AIRPORT LAND USE COMMITTEE (ALUC)

AGENDA

Subject: Review and recommend approval of a determination of conditional consistency for the City of South San Francisco, Gateway Hotel Project with the Comprehensive Airport Land Use Compatibility Plan for the Environs of San Francisco International Airport

Subject: Review and recommend approval of a determination of inconsistency for the City of San Bruno, Al Madinah Academy project with the Comprehensive Airport Land Use Compatibility Plan for the Environs of San Francisco International Airport

BUILDING ELEVATIONS

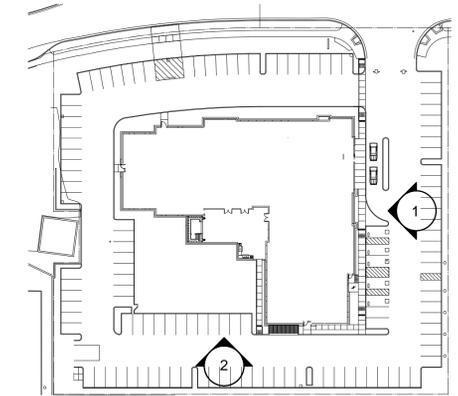
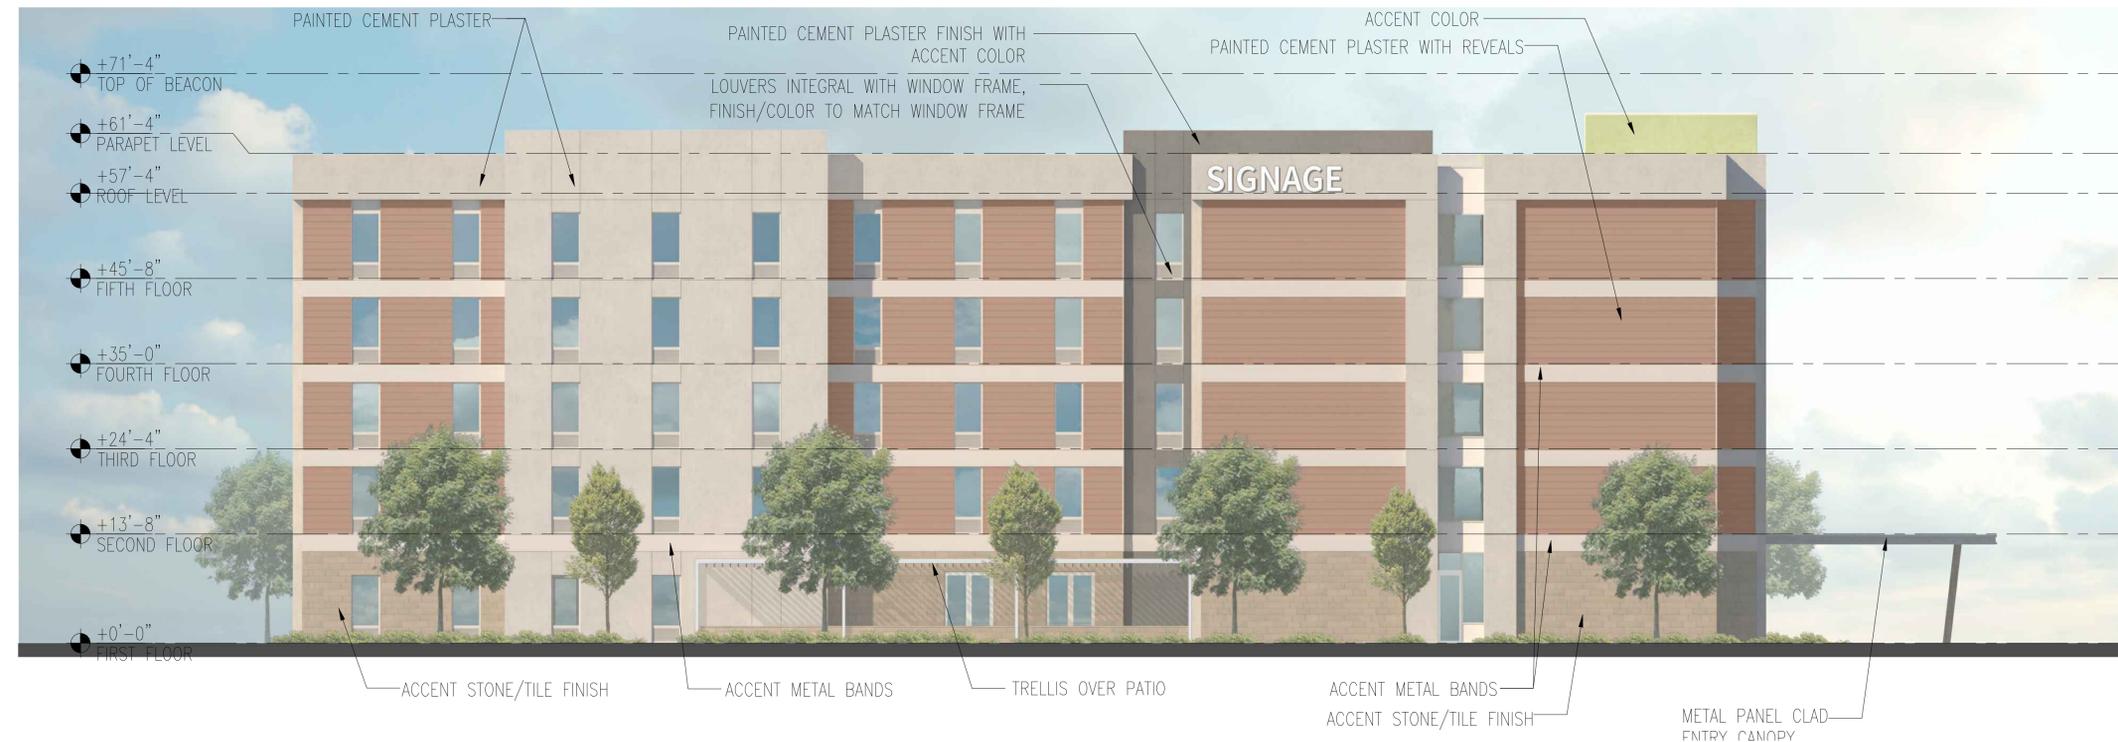
Highest point of structure above mean sea level	Height of structure compared to the imaginary surface of approximately 170 feet above mean sea level
102 feet, 4 inches	Highest point of structure will be approximately 67 feet below the imaginary surface.

At 71 feet, 4 inches this building will exceed the height established on the map for Exhibit IV-10 in the SFO ALUCP. This map displays the ranges of building heights at specific locations that require FAA notification. As a result, the project sponsor shall be required to comply with airspace protection policies AP 1.2 and AP-2.

The Gateway Hotel Project would become fully consistent once the following two conditions have been met:

AP-1.2 FAA Aeronautical Study Findings Required Before Processing Development Application

- The sponsor of a proposed project that would exceed the FAA notification heights, as shown approximately on Exhibit IV-10, shall present to the local government permitting agency with his or her application for a development permit, a copy of the findings of the FAA's aeronautical study, or evidence demonstrating that he or she is exempt from having to file an FAA Form 7460-1. It is the responsibility of the local agency to consider the FAA determination study findings as part of its review and decision on the proposed project.

AP-2 COMPLIANCE WITH FINDINGS OF FAA AERONAUTICAL STUDIES

- Project sponsors shall be required to comply with the findings of FAA aeronautical studies with respect to any recommended alterations in the building design and height and any recommended marking and lighting of their structures for their proposed projects to be deemed consistent with this ALUCP.

Site Location Relative to SFO ALUCP Compatibility Factor Boundaries

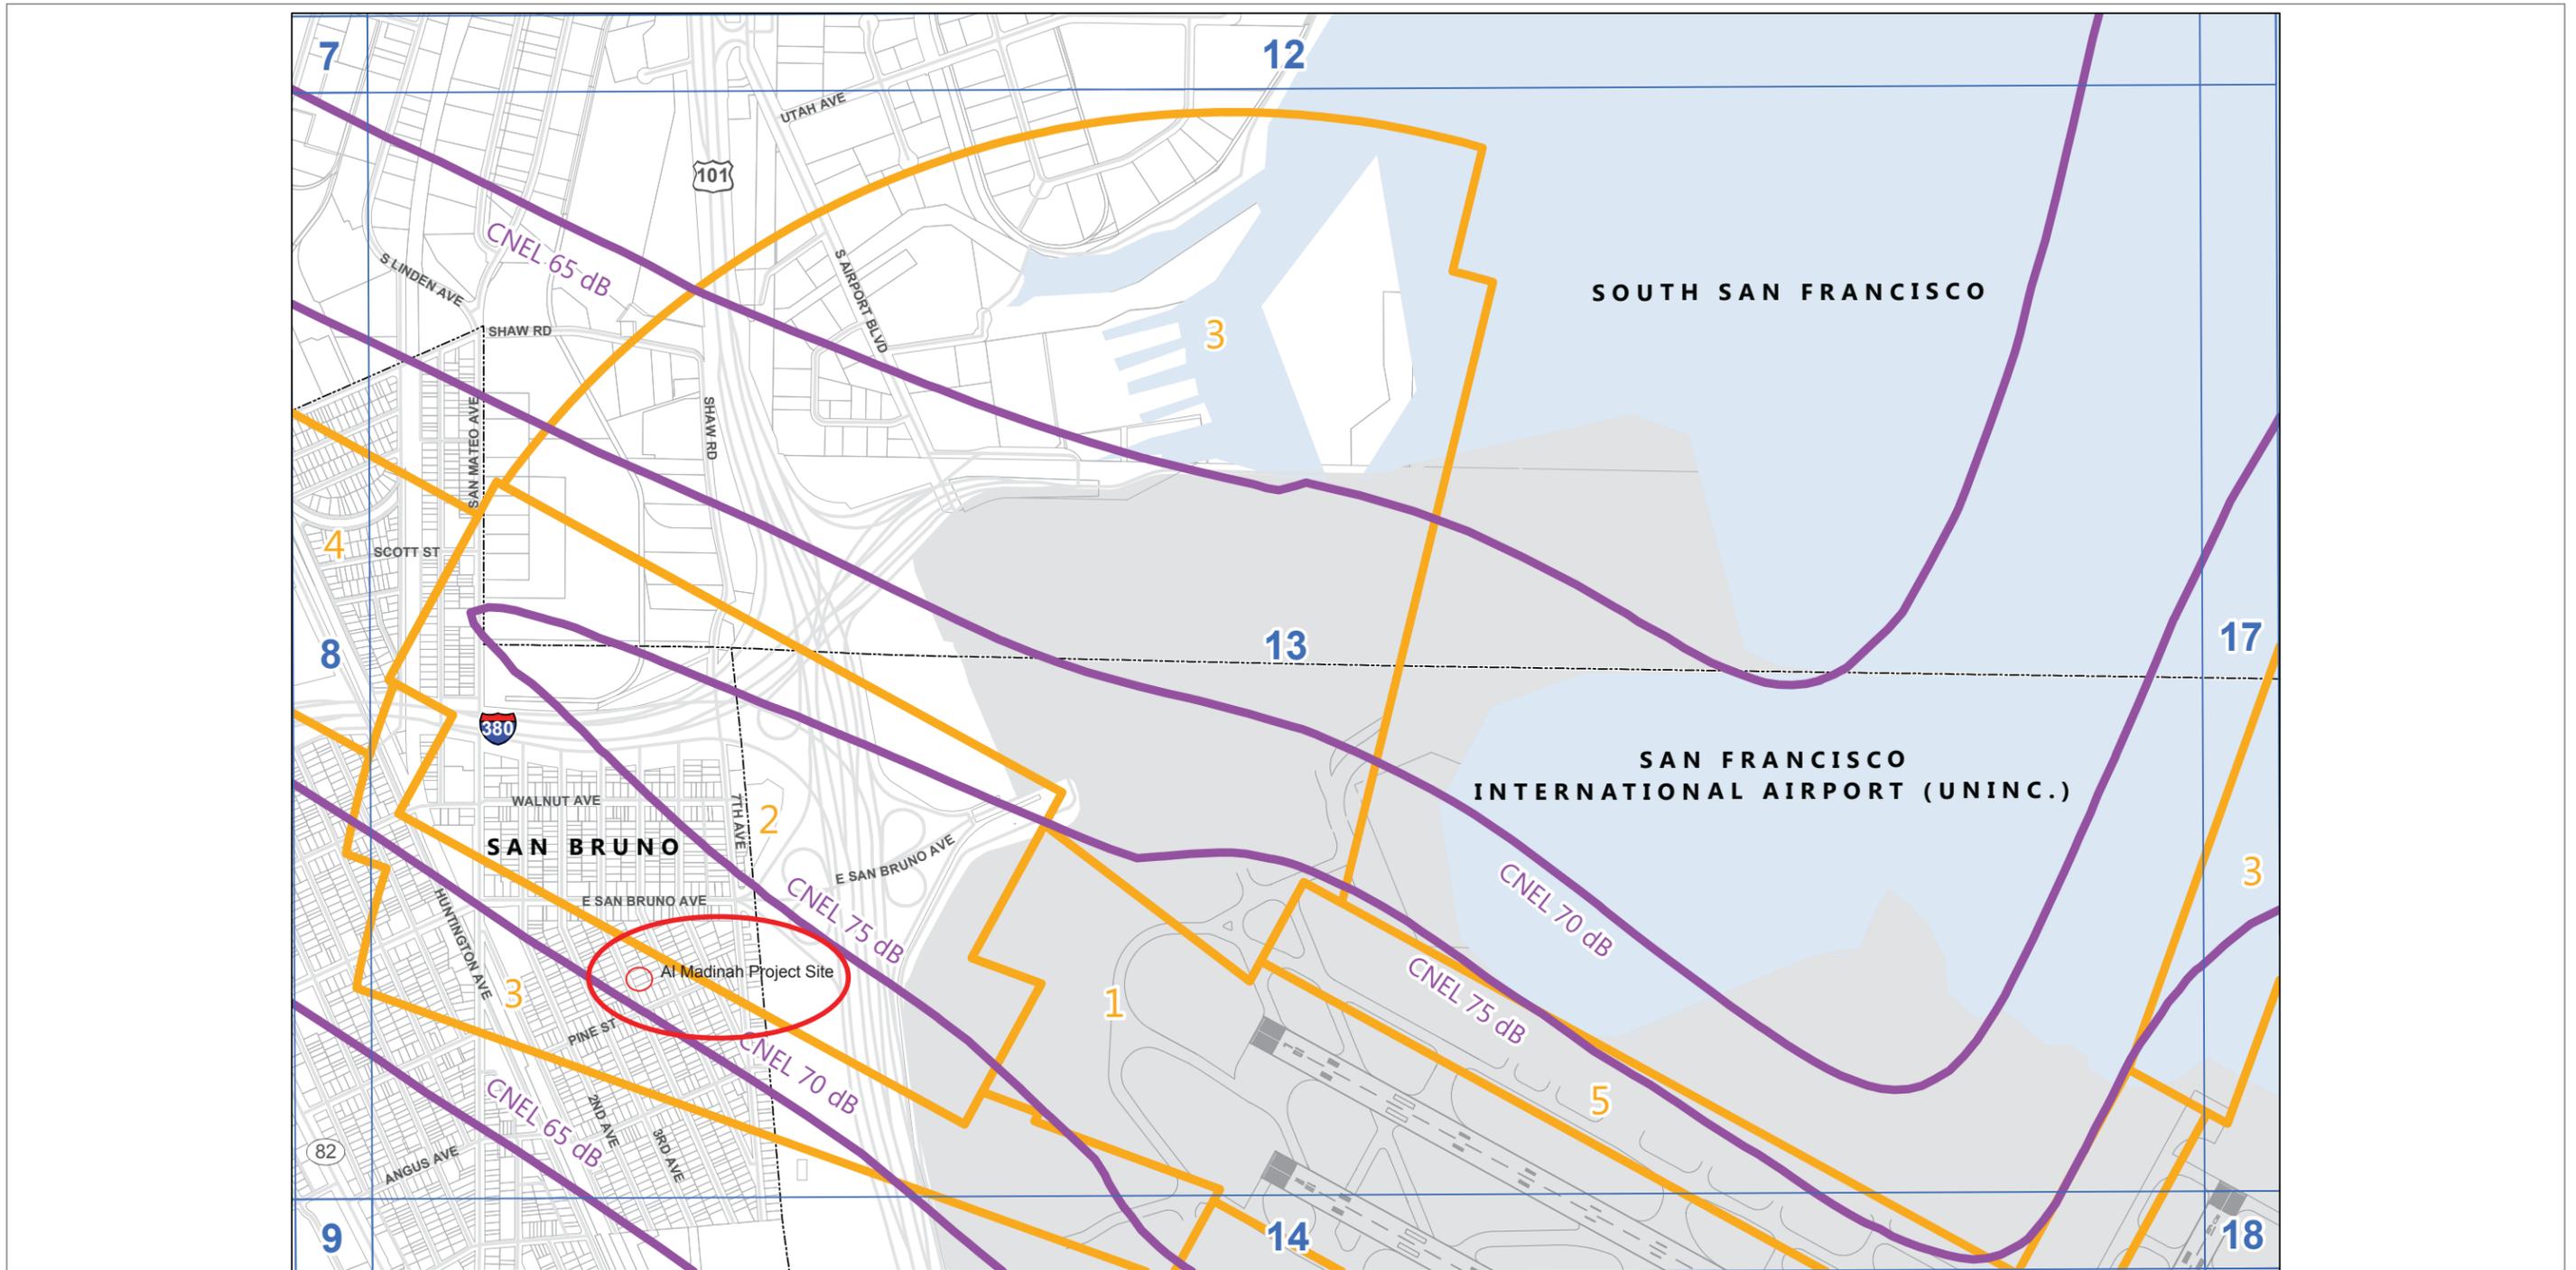
As depicted on Attachment 2, the proposed site of the Al Madinah Academy is located within the CNEL 70 dB contour. Therefore, the Al Madinah Academy project is incompatible at the proposed location.

As depicted in Attachment 2, the proposed site of the Al Madinah Academy is located within Safety Zone 3, the inner turning zone for Runway 10R-28L. Within Safety Zone 3, biosafety level 3 and 4 facilities, children’s schools, large child day care centers, hospitals, nursing homes, stadiums, and arenas are incompatible uses. Hazardous uses other than biosafety level 3 and 4 facilities as well as critical public utilities are categorized as “avoid.”

Exhibit 3 – Site Location
Relative to CNEL 70 dB Contours, 1996 CLUP and 2012 ALUCP

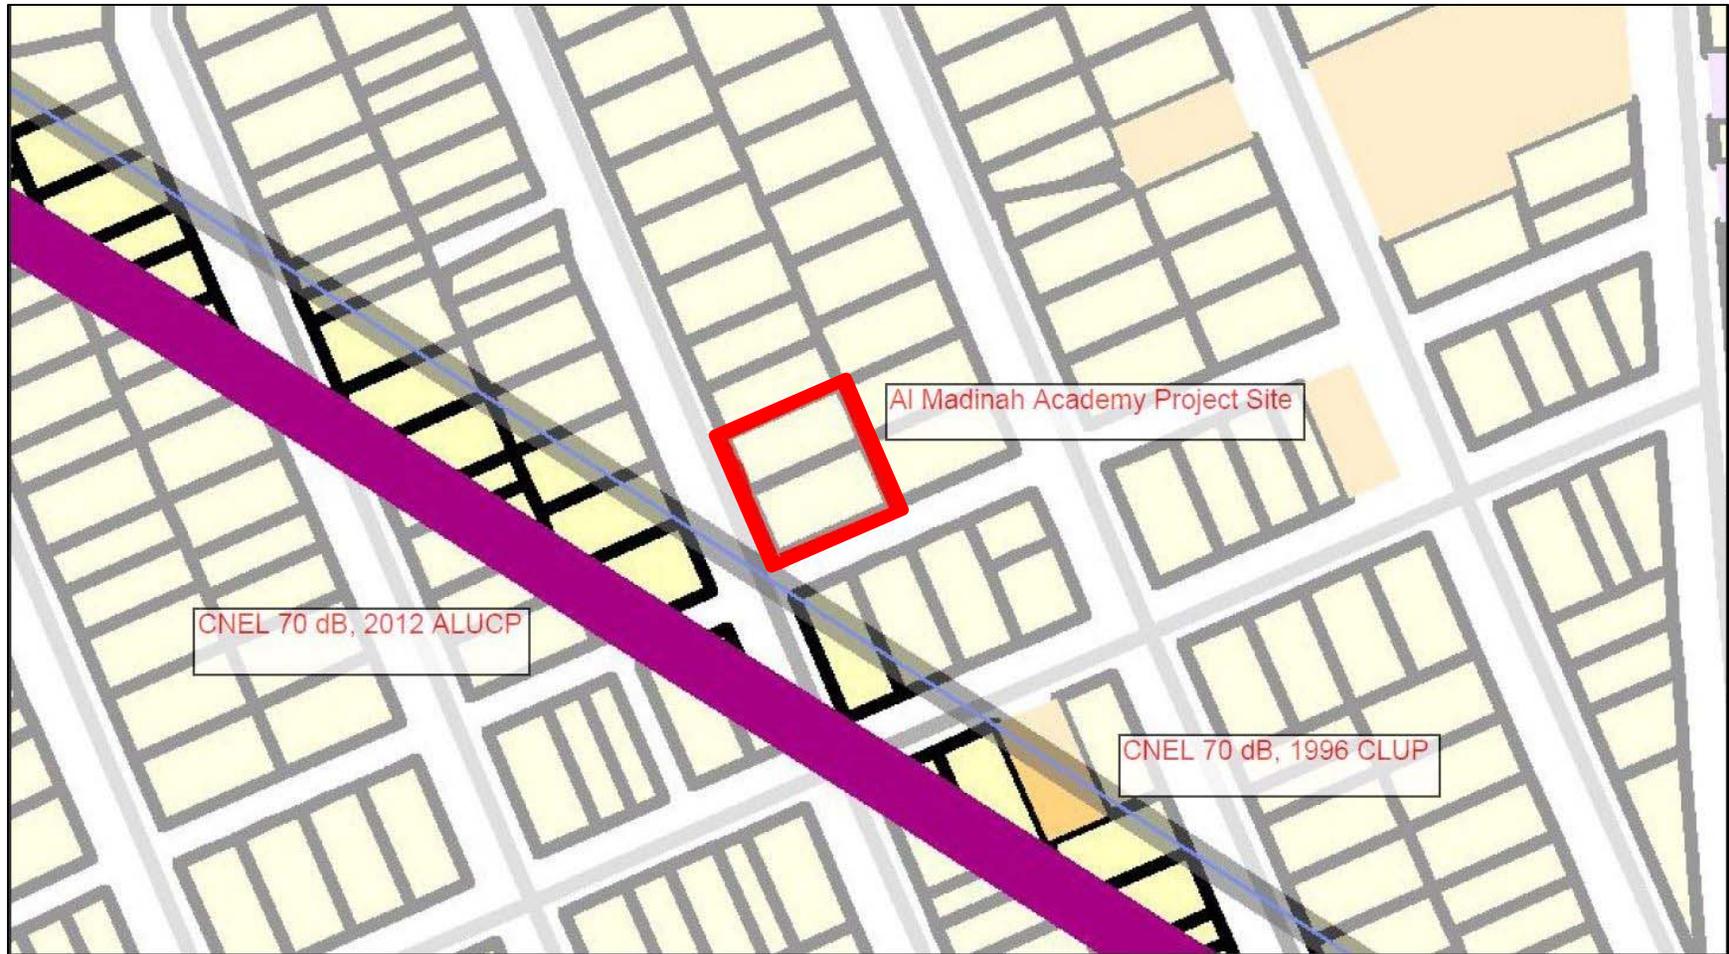
Planning officials of the City of San Bruno have explained that the application for this proposed development action was deemed complete prior to the date of adoption of the 2012 SFO ALUCP. They requested that C/CAG staff consider the applicability of Policy GP-5.3 to the proposed project. That policy provides that any development action in the review process before the effective date of the 2012 SFO ALUCP, if located between the CNEL 70 dB contour of the 1996 CLUP and the CNEL 70 dB contour of the 2012 ALUCP, must be evaluated for noise consistency based on the policies of the 1996 CLUP. As depicted in the map below, the proposed project lies within the CNEL 70 dB contours based on both the 1996 CLUP and the 2012 ALUCP. Thus, policy GP-5.3 does not apply to the proposed project.¹

¹ As it happens, the 1996 CLUP policy for places of worship is the same as the policy in the 2012 ALUCP – they are considered incompatible within the CNEL 70 dB contour. See Table V.-II on page V-13 of the 1996 CLUP.

PROPOSED ELEVATIONS
(NEW MOSQUE BUILDING)

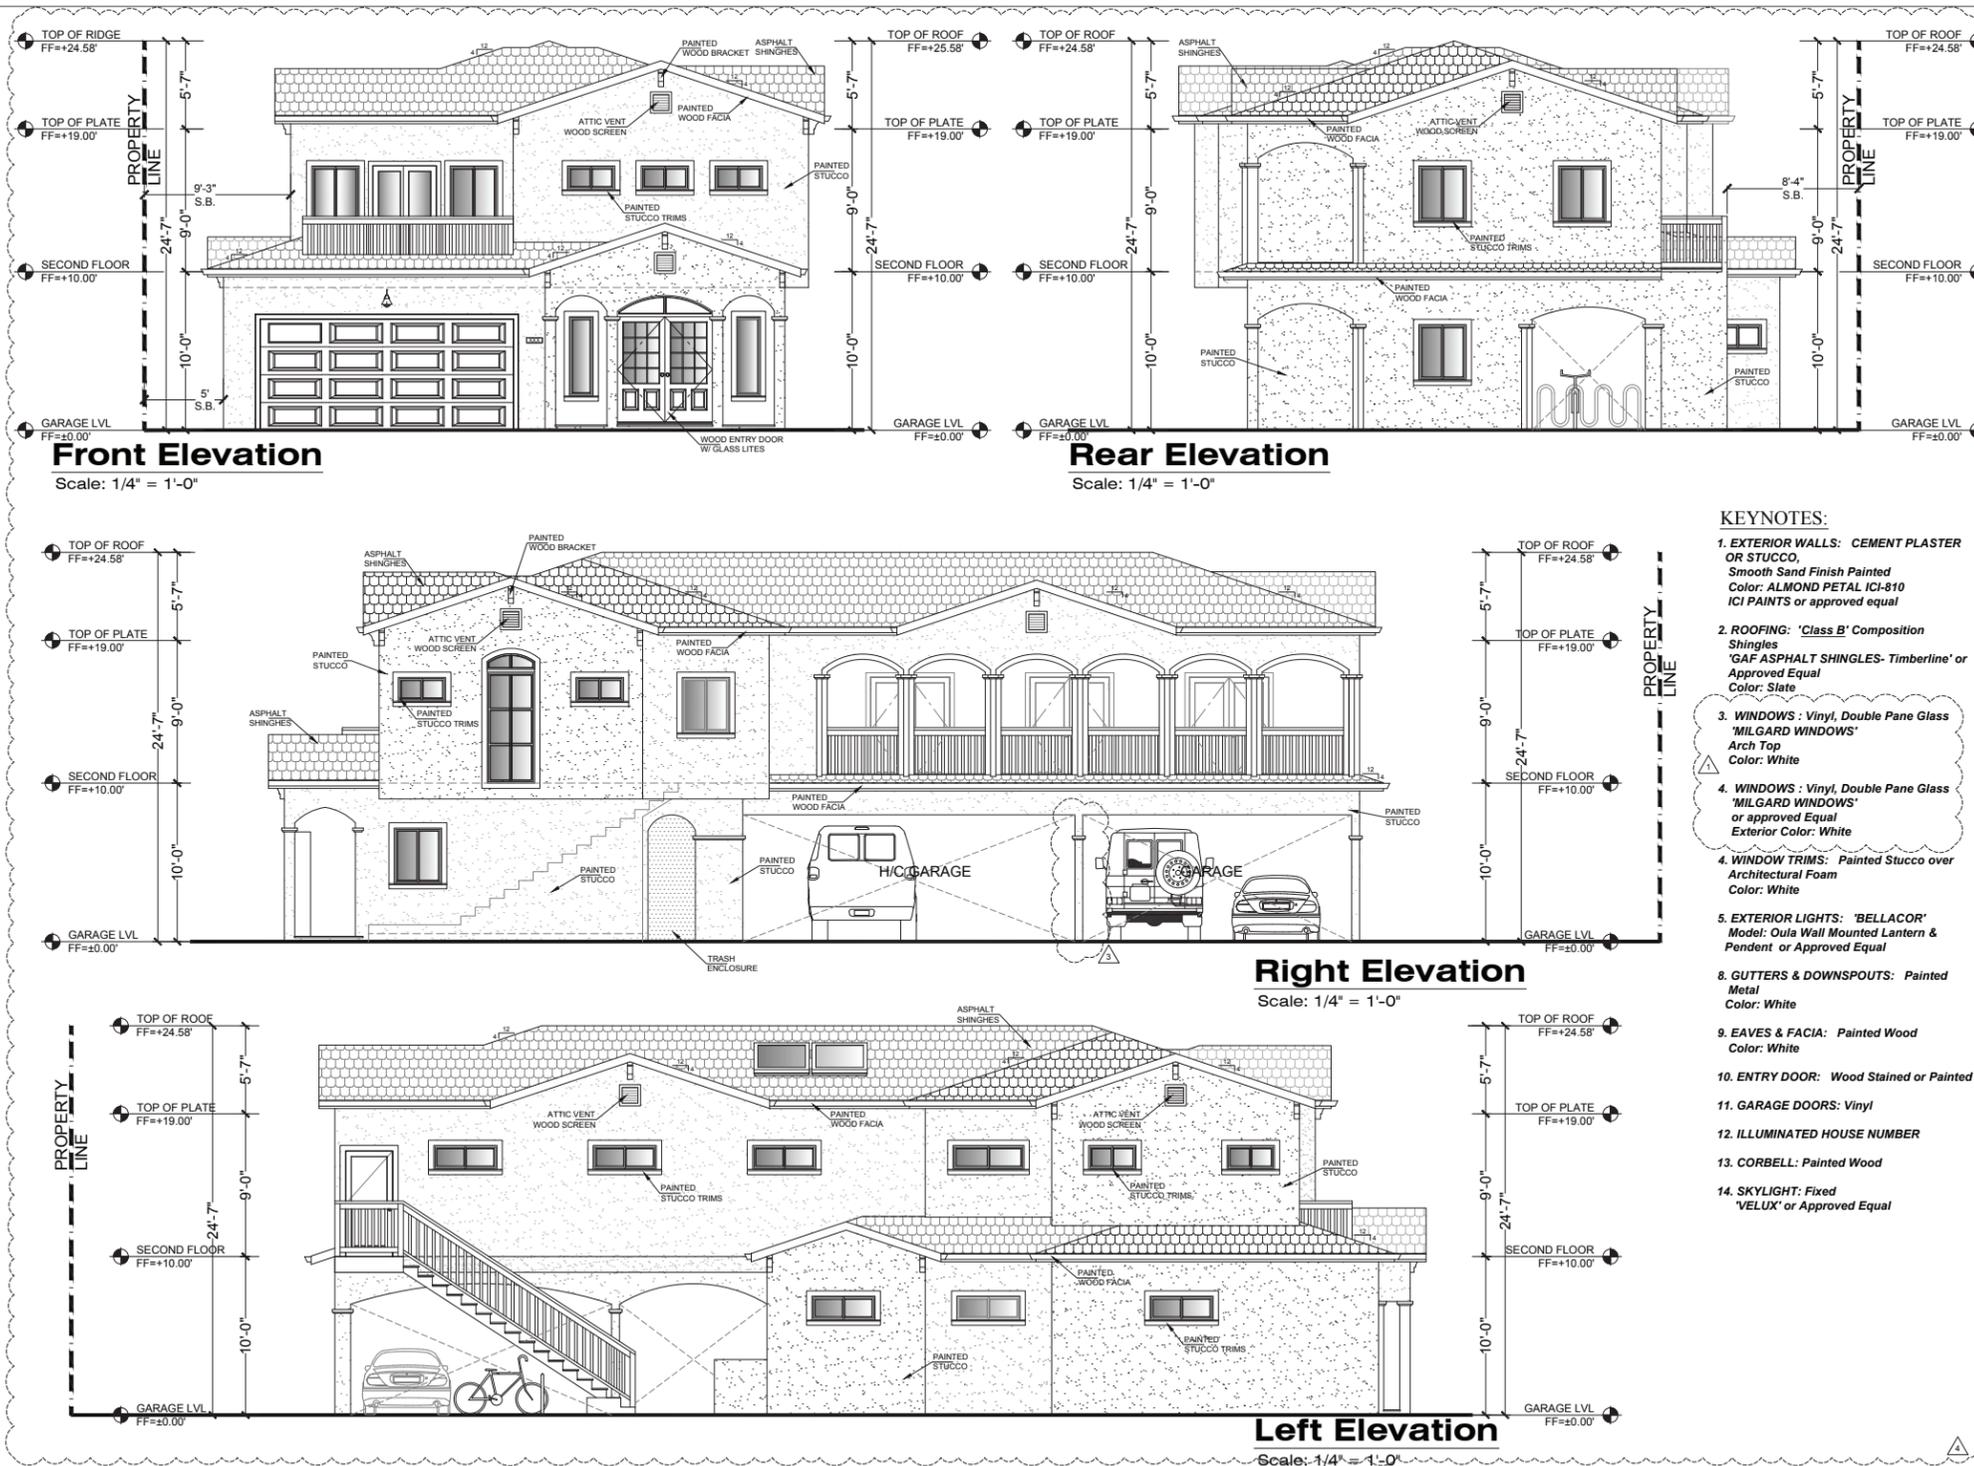
The site of the proposed structure is situated at approximately 11 feet above mean sea level (AMSL). As depicted in Attachment 4, the proposed structure would extend approximately 25 feet above ground level at the highest point, meaning that the top of the structure would be approximately 36 feet AMSL.
